07/28/06

Inspection Report of 6282 S. Military Trail, Lake Worth FL #705 Prepared for Muhammad A. & Nisreen Tina

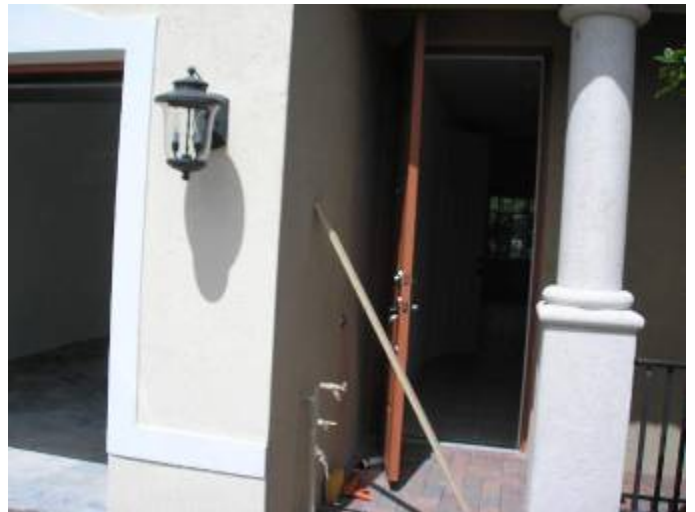
Some of the stucco work appears to be uneven, curved in & not the proper depth. ASTM C 926, §2504.2 §1403.1.3

We recommend core sampling at these locations to verify the thickness of the exterior stucco & compliance with ASTM C 926.

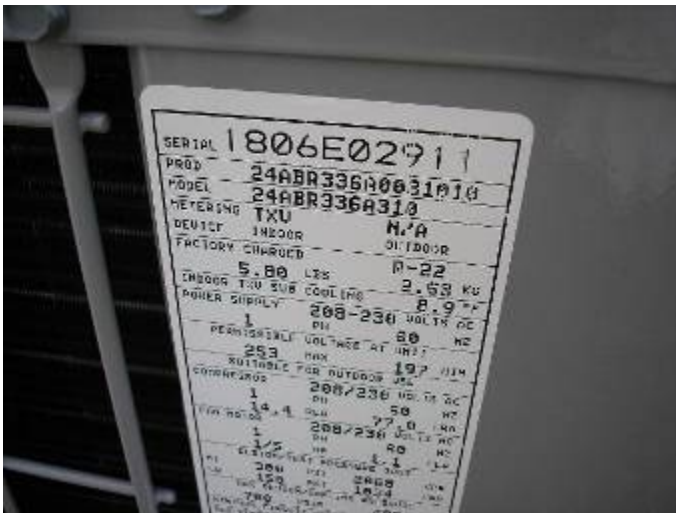
3 Anchors are required on each side of the condensing unit. M301.13.1 The AC refrigerant line piping was not correctly supported at 6 ft intervals as required. §M305.4

The exterior AC refrigerant line piping was not correctly supported at 6 ft intervals as required. §M305.4

Obtain anchorage engineering specs or add anchors as required.

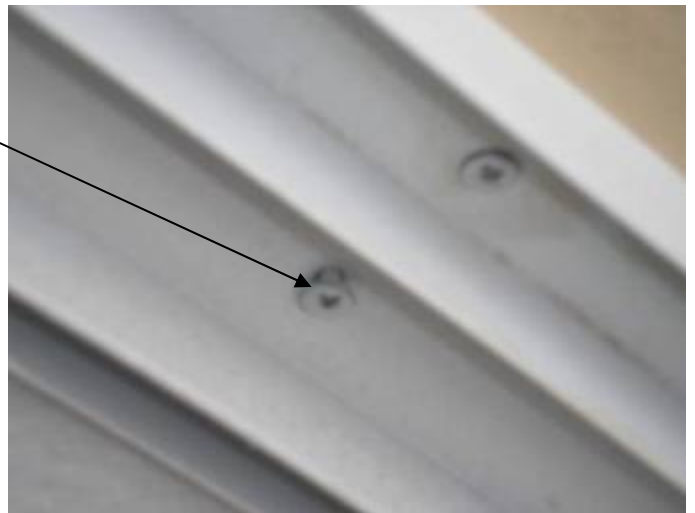
The height of the locks should not exceed 54 inches at the bedroom windows.

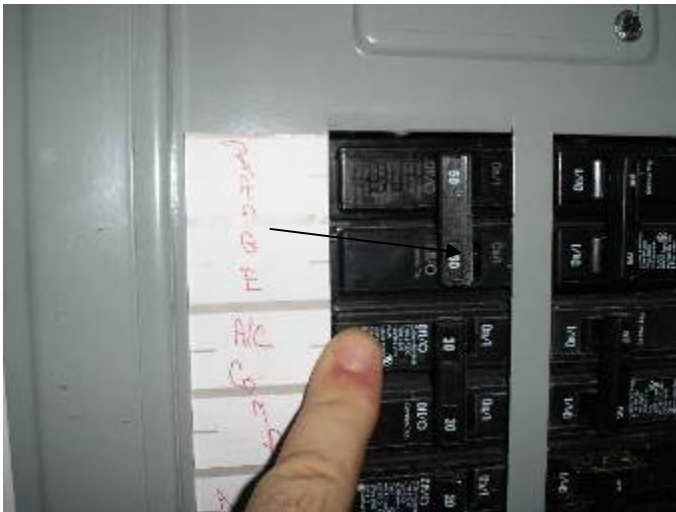
The range is installed with an electrical cord rated at 40 amps. The 50 amp overcurrent protection breaker in the main distribution panel is too big. §M304.1

Review the manufacturer's installation instructions.

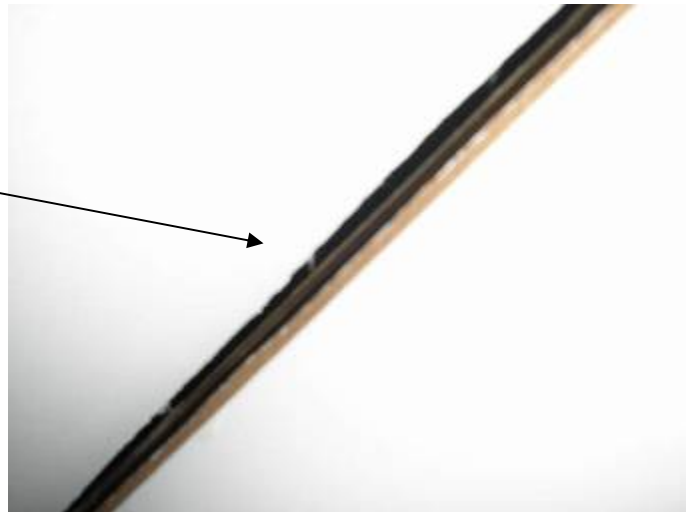
The drywall screws & light gauge metal are not designed to support the weight of persons entering the guest house attic. §2504.5

The 2x4 blocking should be secured through the trusses with 16d nails.

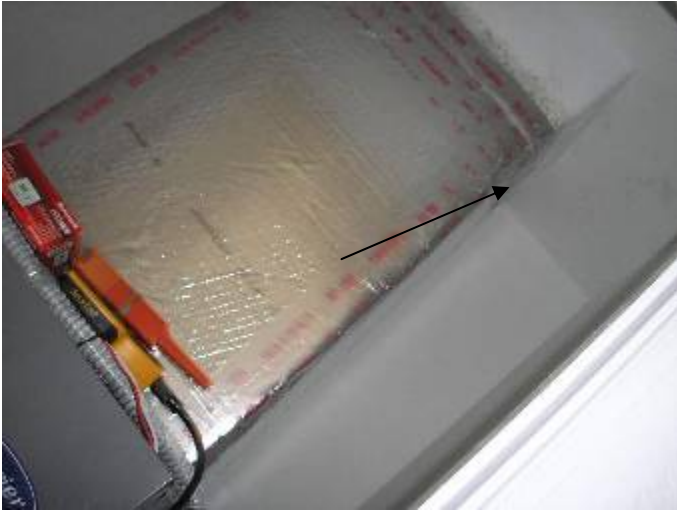
The circuits are not all completely identified to indicate the location of service.

The AFCI arc fault breaker did not move to the fully tripped position when tested.
